IN THE MATTER of the Application for the Waitaha Hydro Scheme

STATEMENT OF EVIDENCE OF JON FRANCIS TUNNICLIFFE ON RIVER
GEOMORPHOLOGY

6. I have been engaged by the EPA to provide an independent technical review of the "Waitaha Hydro Scheme: Assessment of Environmental Effects – Sediment" (the Sediment Report).

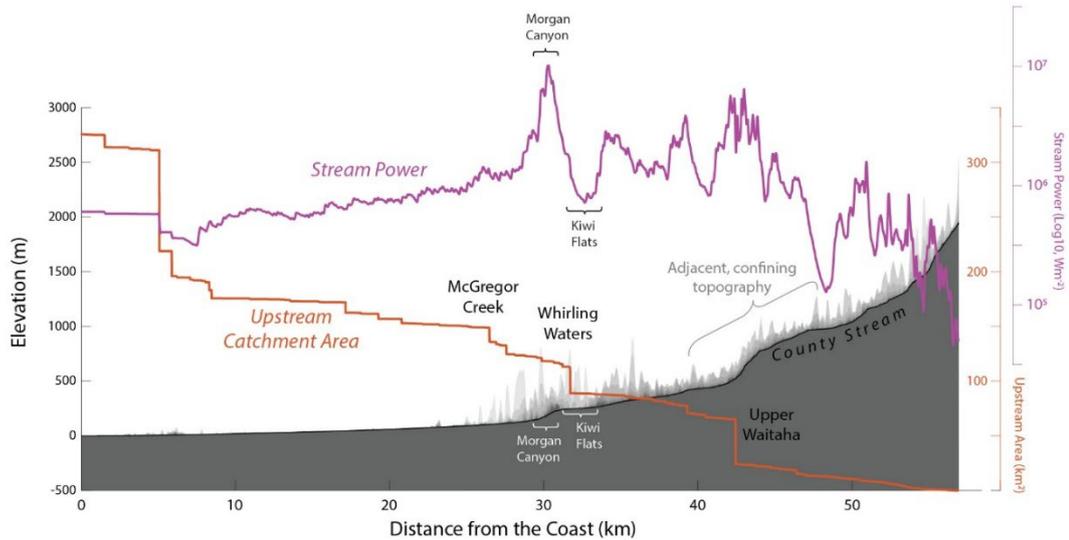
23. Kiwi Flat is an approximately 1.5 km long alluvial reach, up to ~400 m wide, characterised by relatively low channel gradients and active floodplain storage. Immediately downstream, the river contracts into a 15-20 m wide bedrock canyon with substantially steeper slope. Analysis of the longitudinal profile confirms that peak stream power ($\rho g Q S$) occurs within Morgan Gorge itself, while a pronounced reduction in transport capacity is evident upstream, across Kiwi Flat (Figure 1).

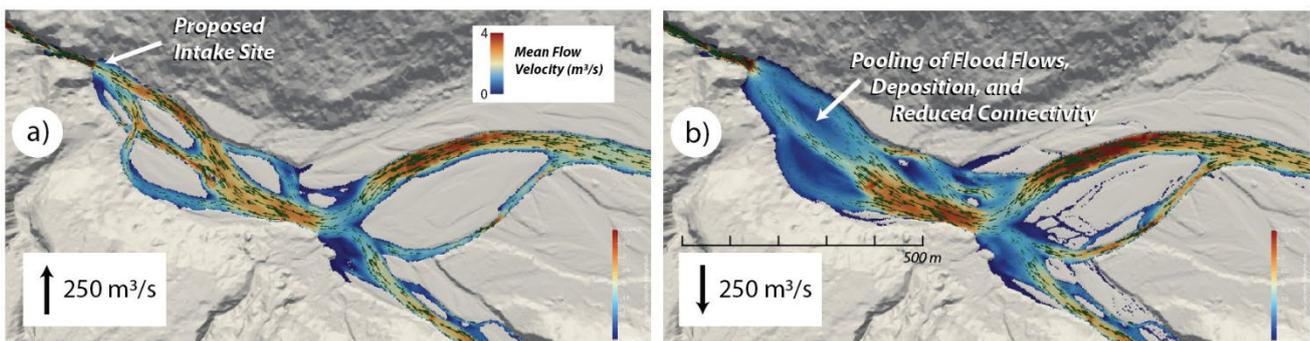
25. Hydraulic modelling indicates that during large floods, backwater effects induced by the gorge constriction dominate flow behaviour across Kiwi Flat. As discharge increases beyond moderate levels, upstream transport capacity exceeds downstream conveyance, resulting in net deposition. Extensive slackwater conditions characterise peak and waning flood stages. The flows most effective at evacuating accumulated material will depend on antecedent conditions in the reach, but are likely to occur within a short window on the rising limb of flood events (Figure 2).

26. The introduction of a weir at the gorge head would alter this delicate balance by: (a) reducing effective longitudinal slope across Kiwi Flat; (b) extending backwater effects further upstream; (c) reducing bed shear stresses during the critical rising-limb transport window; and (d) promoting additional sediment deposition upstream of the weir. Even a relatively low structure would shift the reach from transient sediment storage toward persistent accumulation. While this effect was anticipated for the initial weir emplacement, there does not appear to be a plan to manage potential ongoing aggradation and channel dynamics.
